HENDERSON COUNTY PLANNING BOARD

SUBJECT: Master Plan for Dodd Meadows Major Subdivision (File #2010-M03)

Henderson County Planning Department Staff Report

Master Plan Review for the Dodd Meadows Major Subdivision (File #2010-M03) Henderson County Habitat for Humanity, Inc.

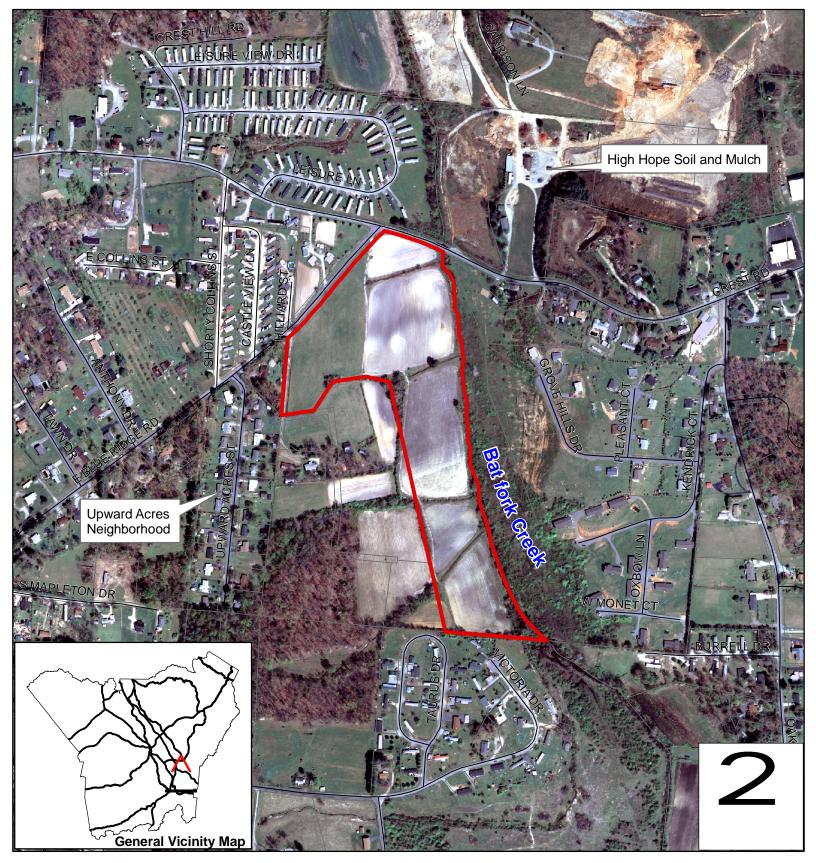
10. **Public Road Standards.** All roads proposed for public use shall be annotated "public" on plans and plats and shall be designed and constructed in accordance with the standards necessary to make the roads eligible to be put on the State Highway Maintenance System at a later date. Such standards are contained in a publication of the North Carolina Department of Transportation, Division of Highways, titled "Subdivision Roads – Minimum Construction Standards," a copy of which is available for review in the office of the Subdivision Administrator. Pursuant to NCGS §136-102.6(d) the NCDOT District Engineer's Office must sign a certificate of approval provided on the face of the final plat for any subdivision where public roads are proposed prior to County approval of the final plat (§200A-81 C).

Staff recommends that the northern most road loop back into Volunteer Way and designated a one way road. This will limit road widths and construction costs, as well as, alleviate concerns with dead end roads. In order to avoid traffic problems staff also suggests placing the entrance of any one way road at the primary interior intersection of the development.

sheet <u>C-100</u>

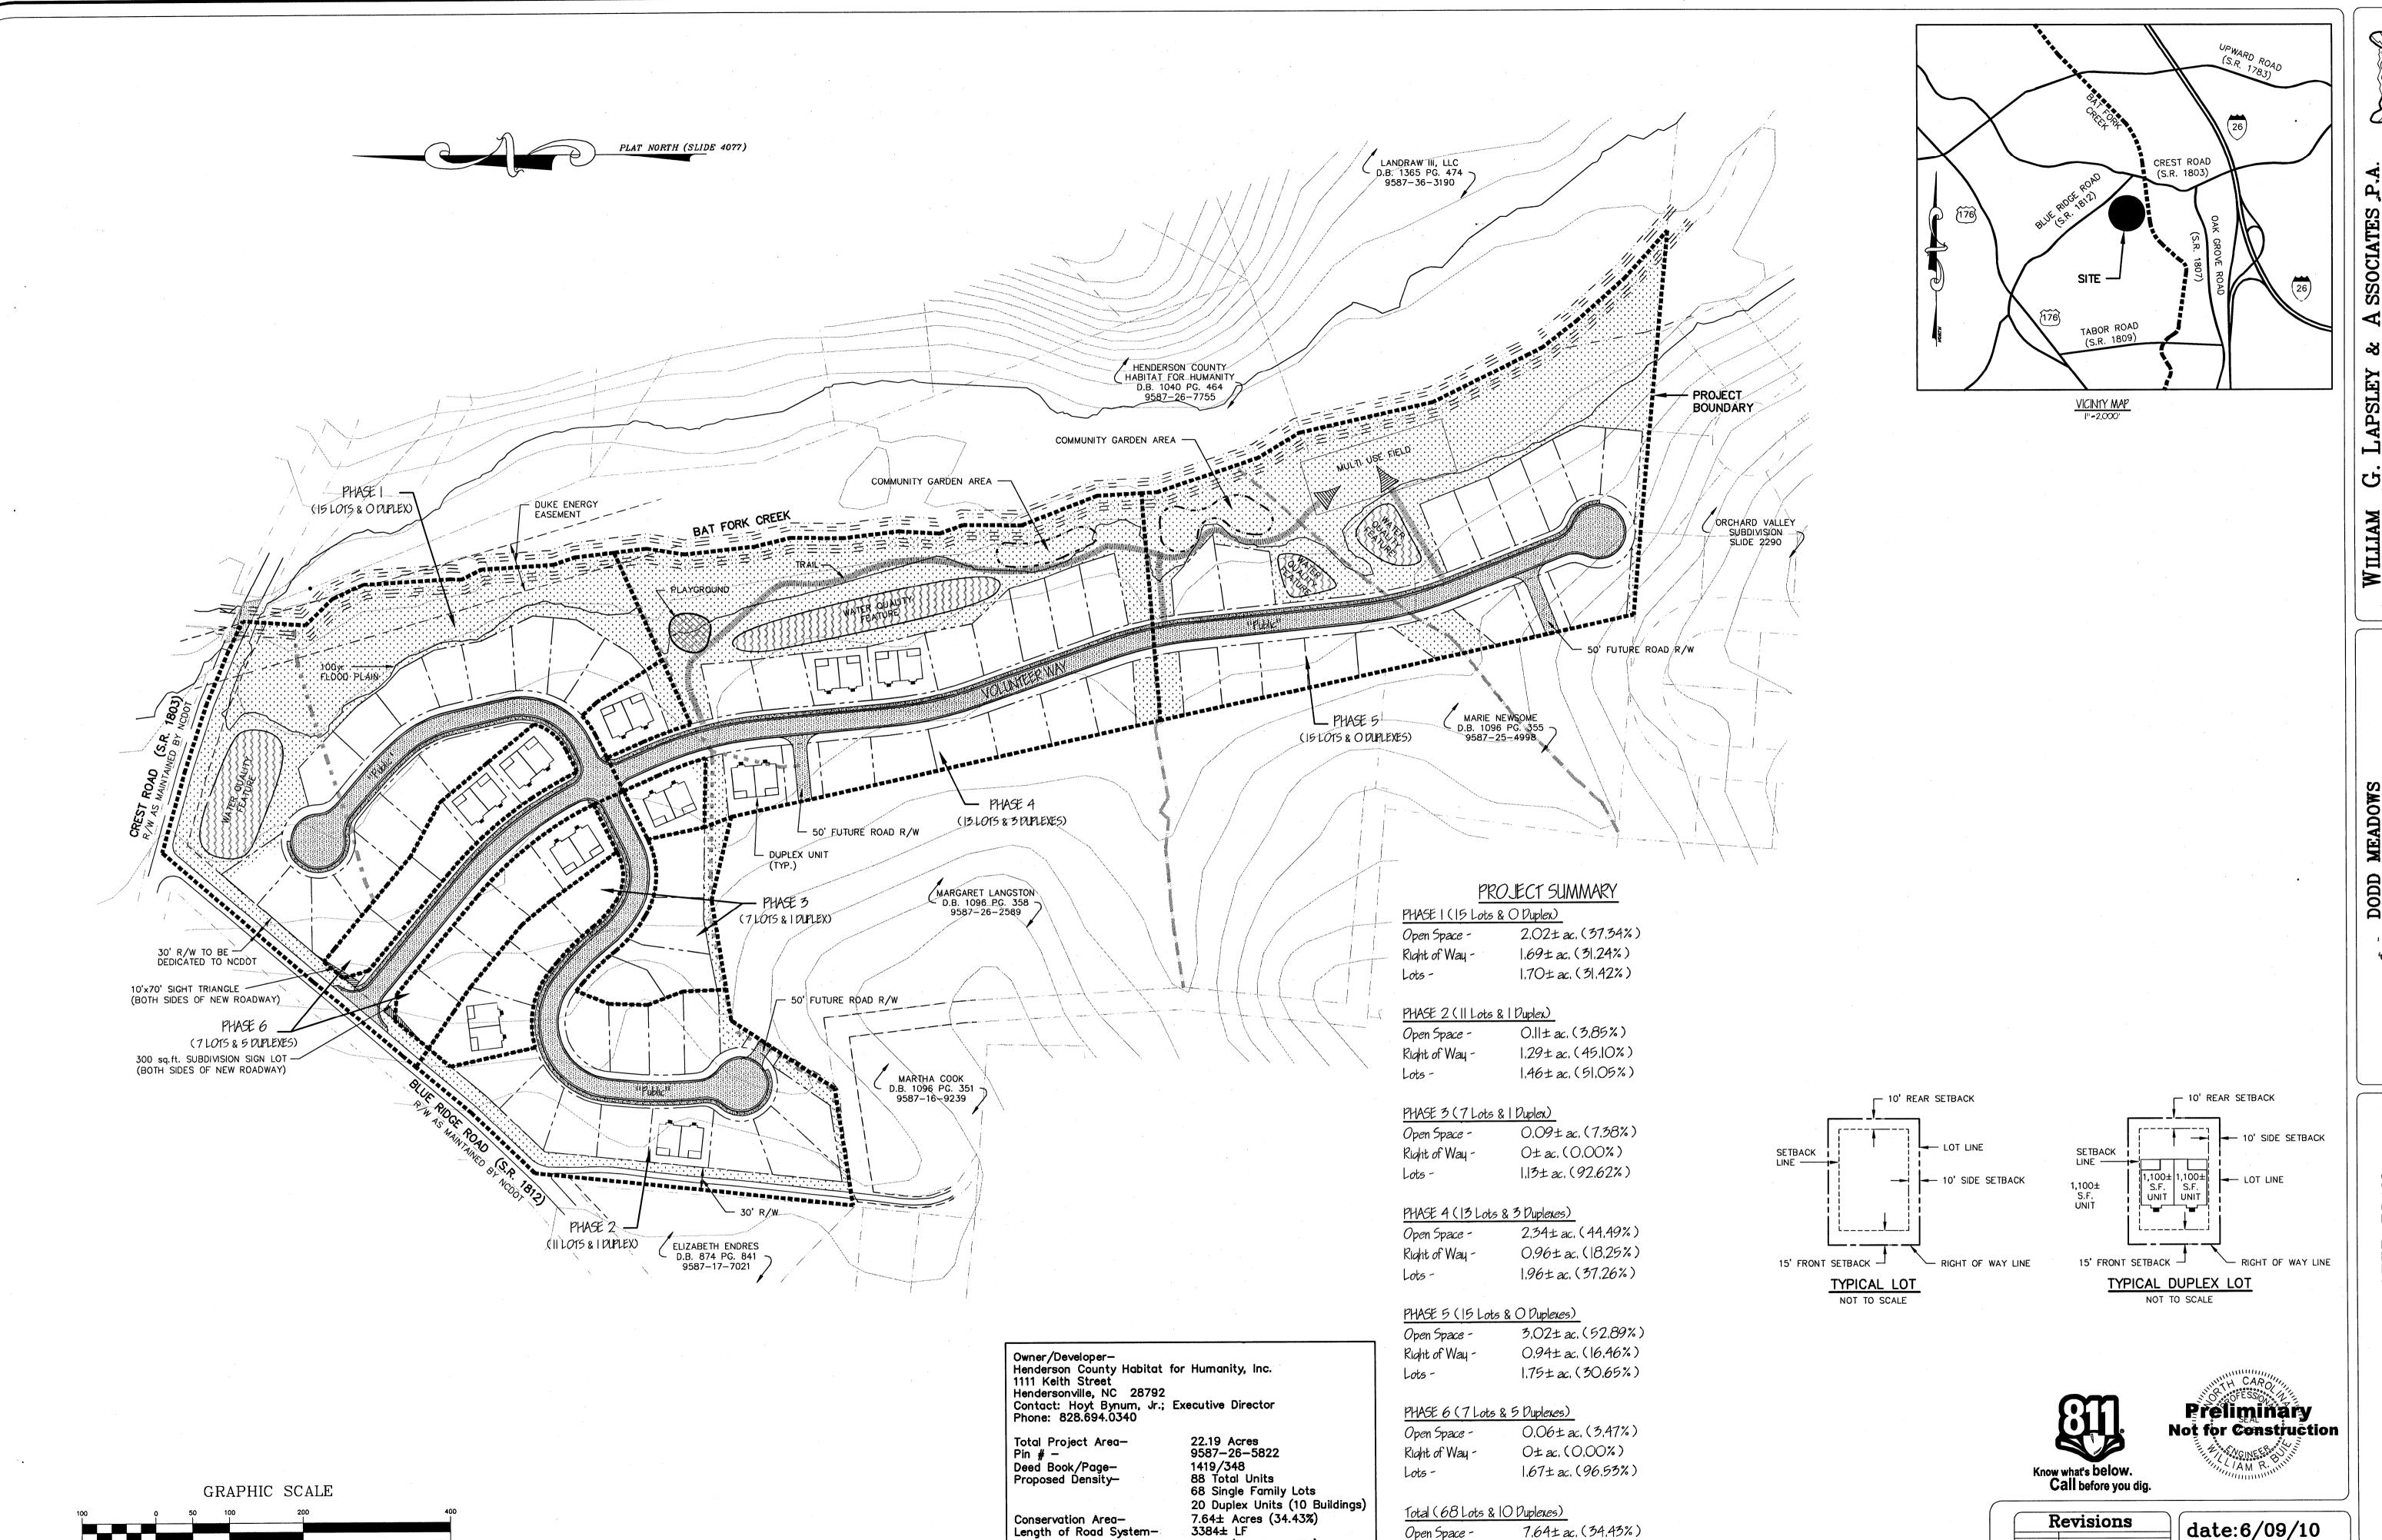
- 4. **Stub Roads and Future Connections.** The submitted Master Plan shows three future connections. Any existing or proposed on site rights-of-way must be built and constructed to the Major Subdivision road standards of LDC §200A-81C. The proposed stub roads must be constructed to the edge of the property line being developed to be considered a future connection (LDC §200A-81C).
